DEVELOPMENT REVIEW BOARD REPORT

SUBJECT **Windmill Ranch
4-PP-2005**

REQUEST Request approval of a Preliminary Plat for an eight-lot single family residential subdivision development on a 19.62 acre parcel.

<p style="text-align: center;">Stipulations for Case: 4-PP-2005 Case Name: Windmill Ranch Preliminary Plat</p>
--

WINDMILL AND STAGECOACH PASS PRELIMINARY PLAT

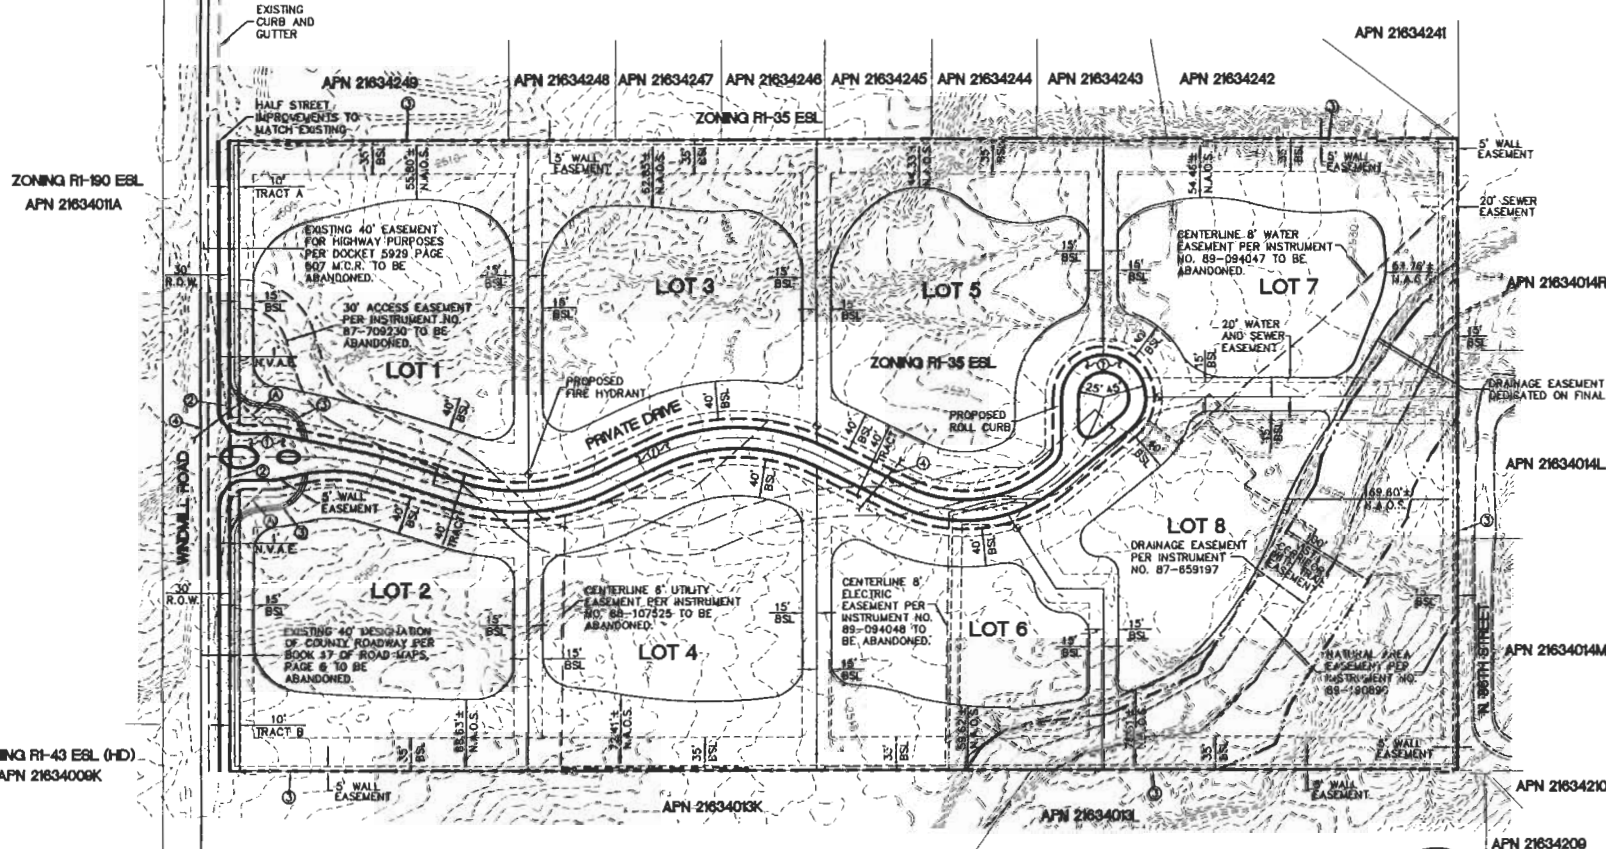
8. Proposed coyote fence shall not be located within large wash running through southeast portion of wash. Any existing improvements within the corridor will be removed and the area returned to a natural condition.

9. Decorative pavement shall not extend into Windmill Road right-of-way.
